Consideration of a request for Preliminary Plat approval for the MEE Estates Subdivision, a 7-lot subdivision located at 950 East 1400 North in the RA-2 Zone.

MEE Estates
Preliminary Plat
Utah
Mapleton City

Development Review Committee Minutes

On March 3, 2021, John and Frank Edmunds re-submitted plans for the MEE Estates Subdivision, now consisting of 7 lots in the RA-2 zone and located at approximately 1000 East 1600 North. Revised plans were submitted on March 3, 2021. The items below include 1) requested changes to the submitted plans, 2) other items required as part of the application and/or 3) informational items regarding city standards.

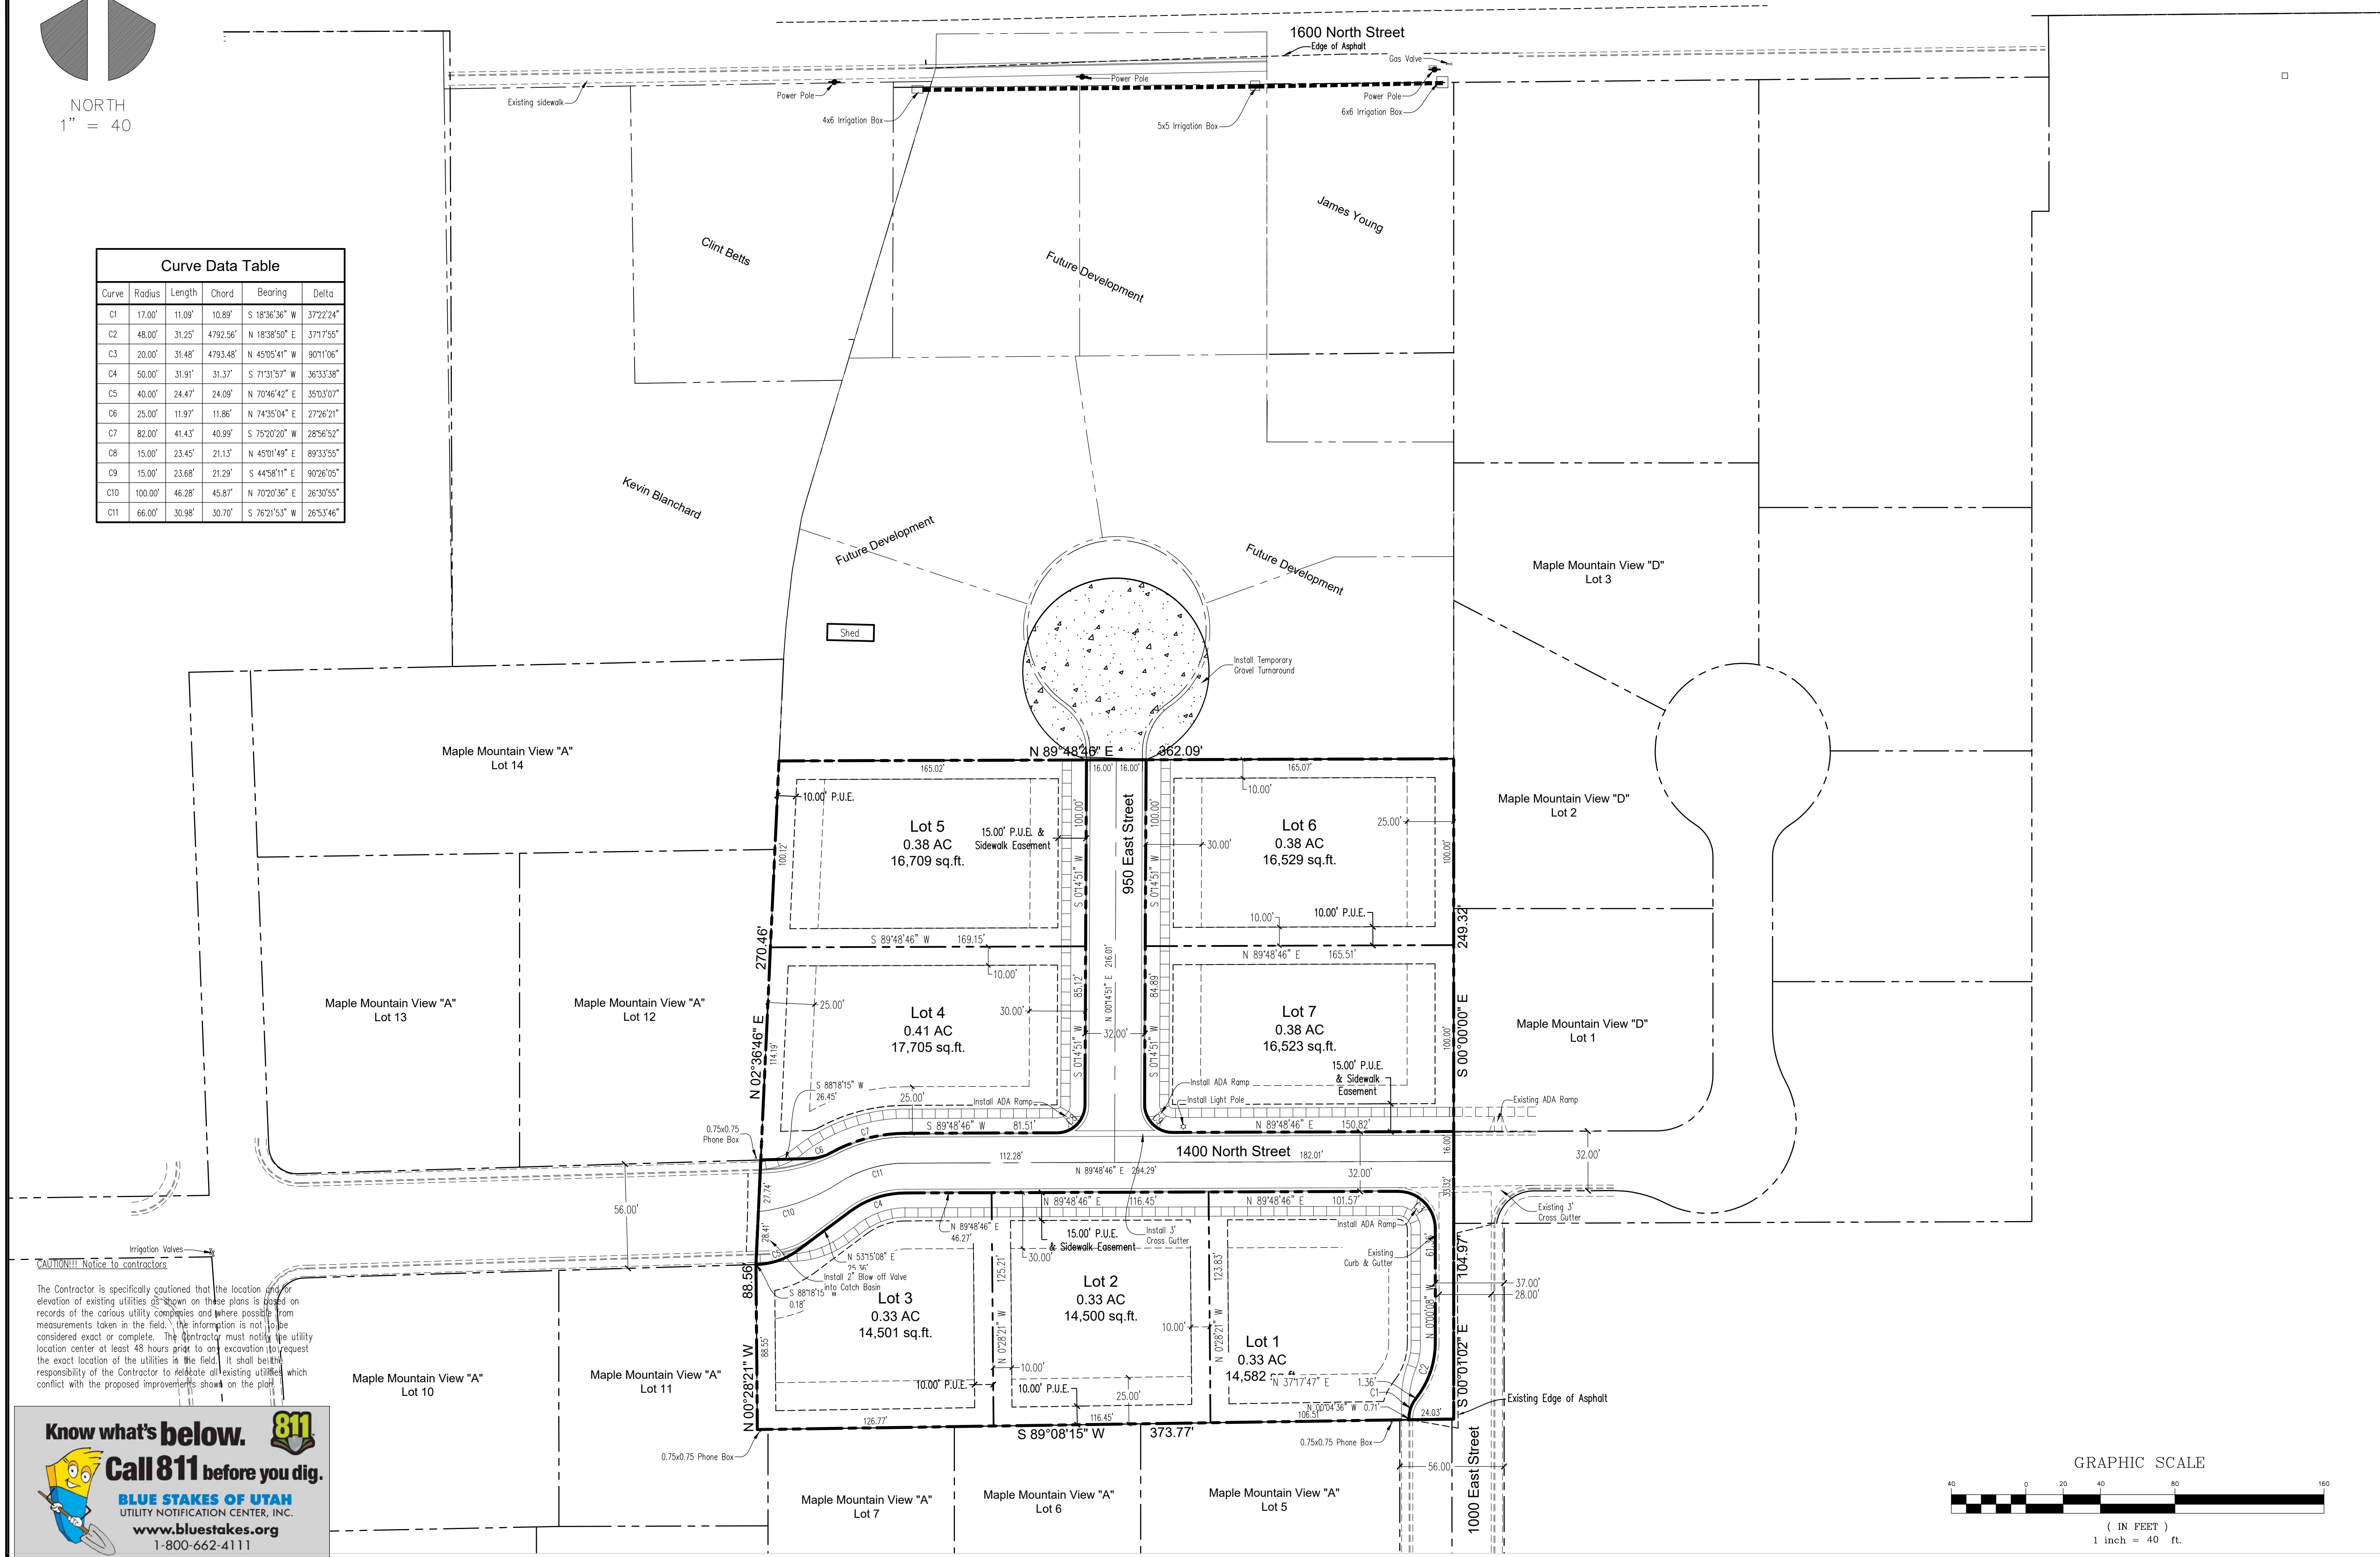
1. The final plat must include, among other requirements, the following:
 - a. A final plat stamped and signed by the Surveyor of Record.
 - b. A dedication block and signature lines for all property owners. The owners will need to sign the plat exactly as they signed the deed to the property and must print their names underneath their signatures to match the signatures. In addition, properties in trusts must include the title of the signer, the full name of the trust and the date of the trust.
 - c. Addresses must be shown on the final plat. **The assigned addresses are attached to these comments.**

- d. In accordance with the standards of the Utah County Recorder, the names of the Owners must be printed in the Acknowledgement as the persons who appeared before the notary. It is useful for the plat to contain a space within the acknowledgment text for the names to be written. Other standards may apply for trusts and corporations. Please communicate with the Utah County Recorder's Office for the specifics for this requirement.
 - e. Please include a signature box/line for Mapleton Irrigation.
2. Boundary line issues exist between the subject parcels and the neighboring Perrero, Kearl, Paxton and Harrison properties. These must be resolved prior to recording the subdivision plat.

Utility Plan

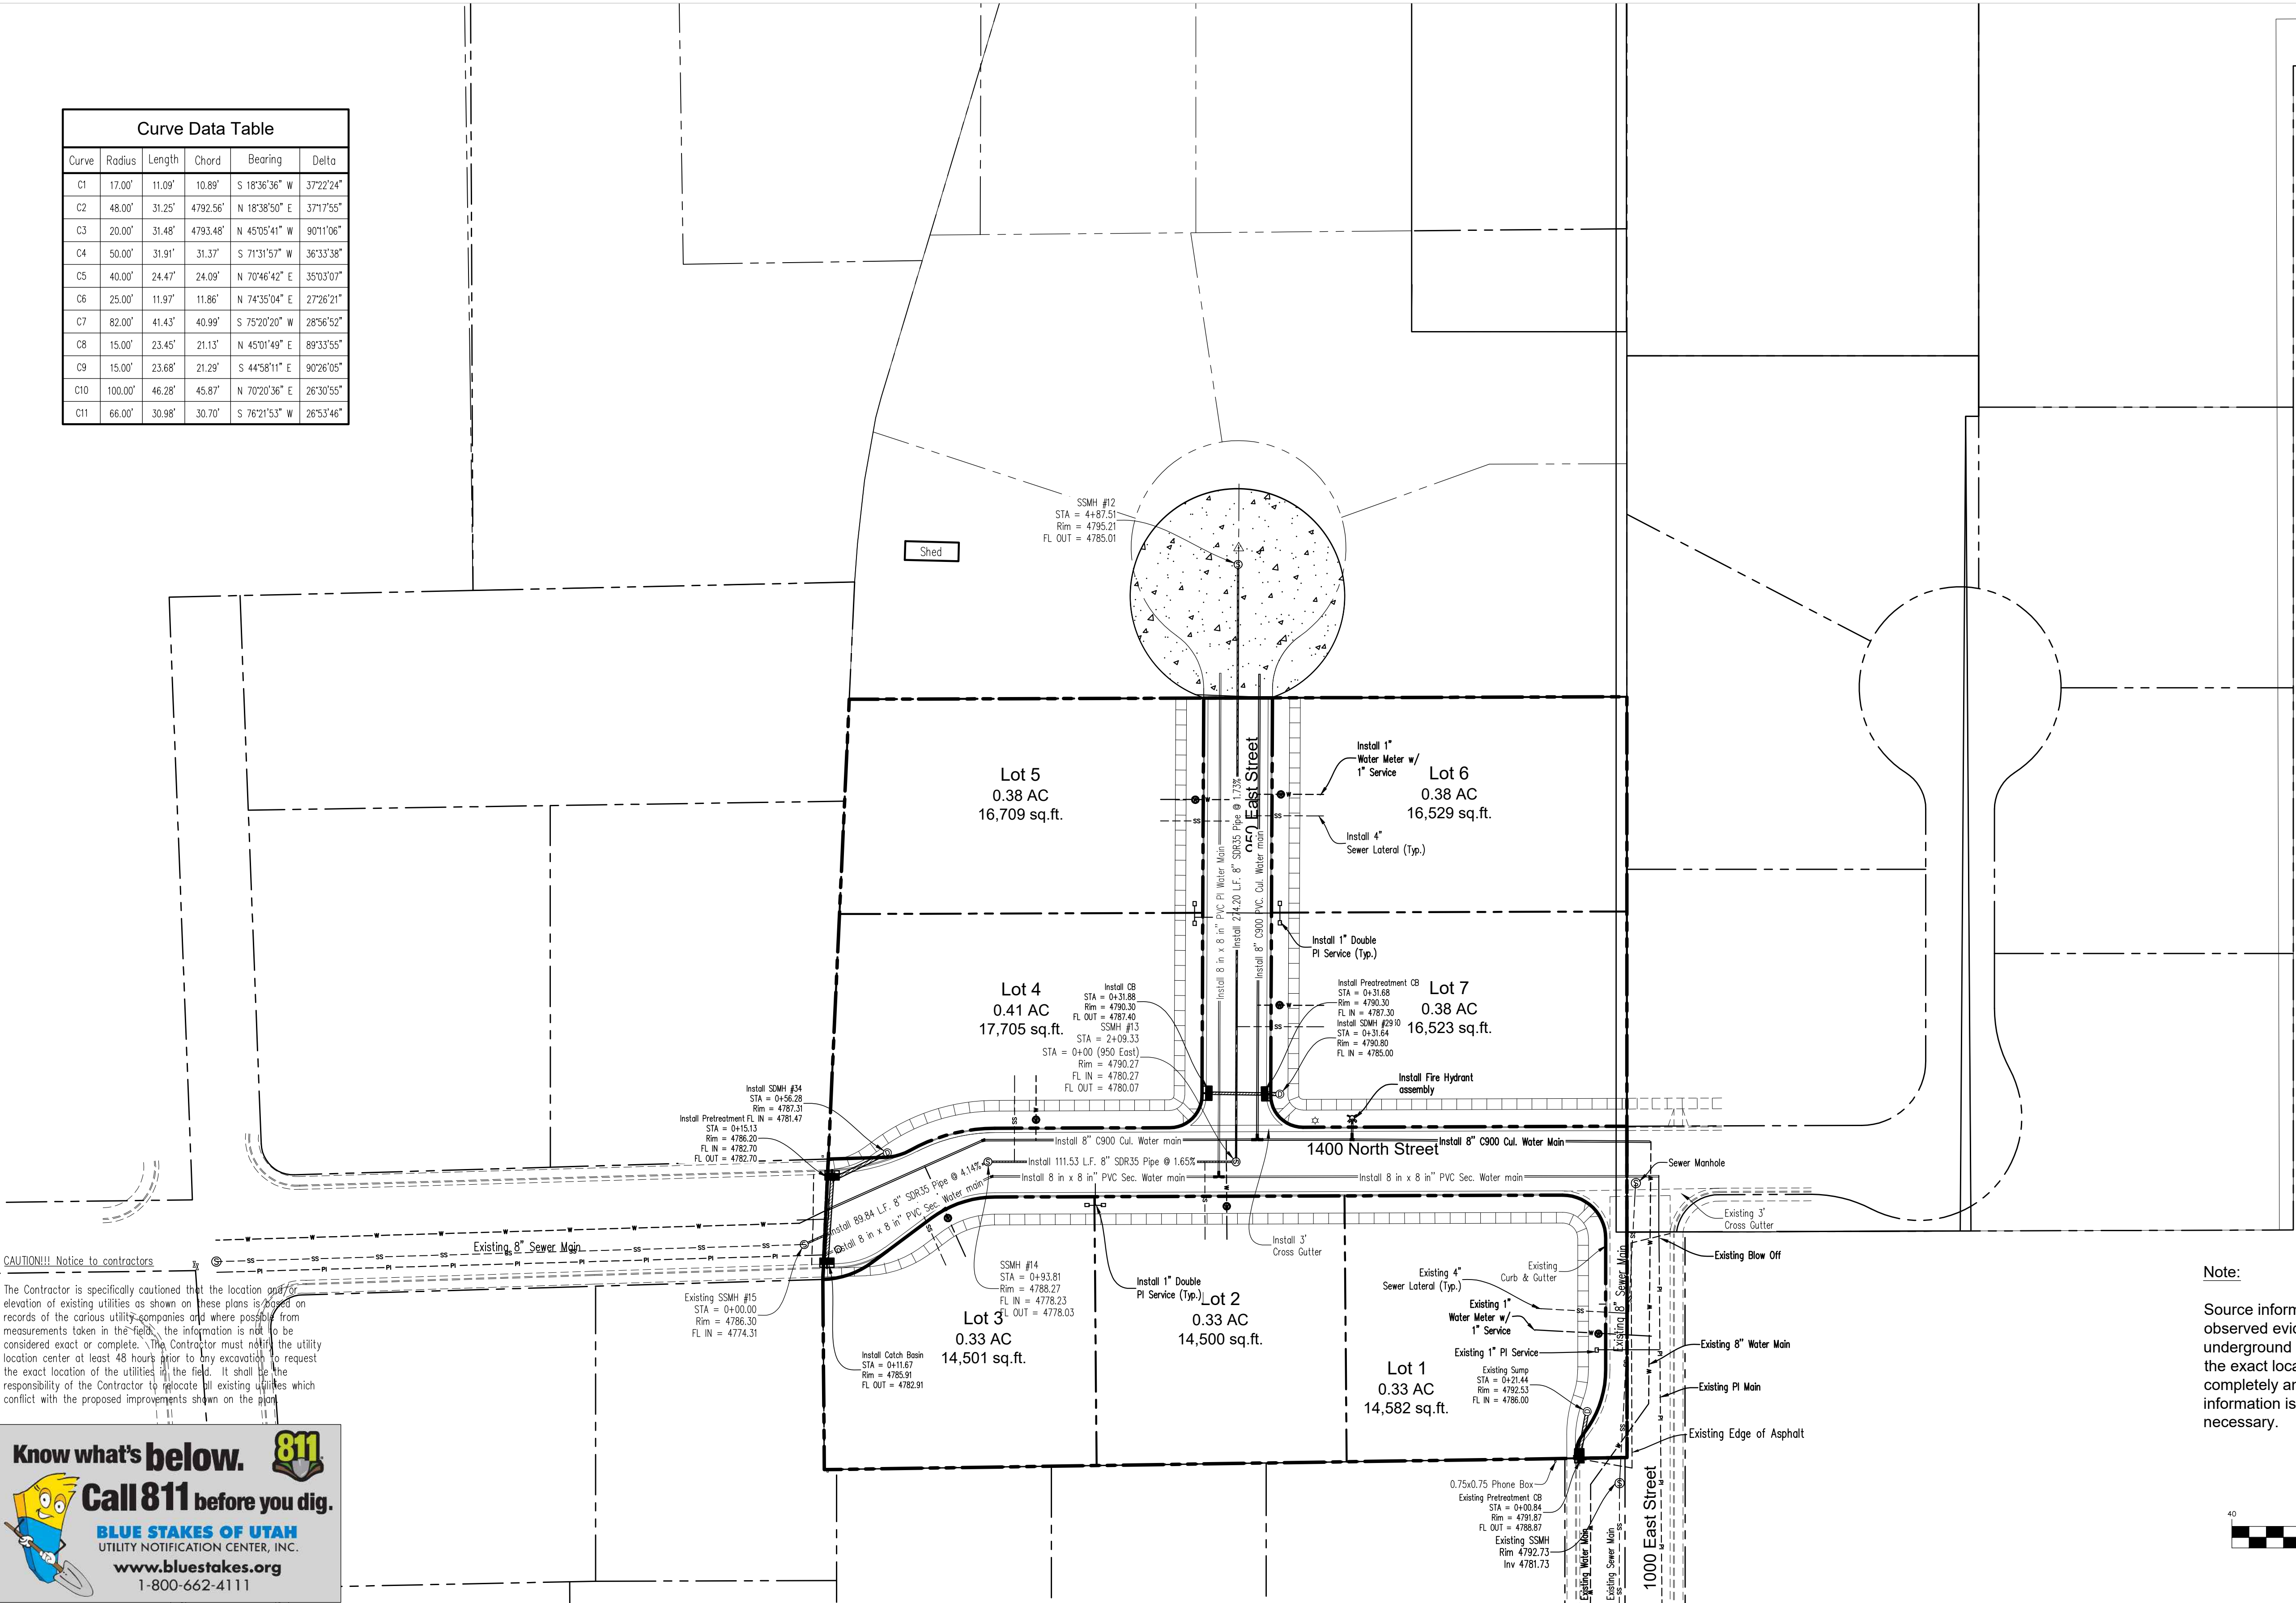
1. Verify location of tie in to 1000 E. I think the existing valve is about 10' north of your design

2. Please install a 2" drain to a storm drain inlet at the low point of the system
3. Remove existing PI line work in 1400 North, east of the development, there is no PI line there to connect to
4. Plug and Cap the PI line on the east end of 1400 N and the north end of 950 E
5. Please call out fitting information (tee, cap, 45 degree elbow etc.)
6. Lot 1 PI service was not installed with Mountain View Estates, the service will need to come off of 1400 N.

1. Move fire hydrant to west end of 1400 N
2. Add a fire hydrant to the end of 950 E
3. Add fitting labels
4. Cap and Plug water line at end of 950E
5. Install 8" gate valve at connection to existing line in east end of 1400 N
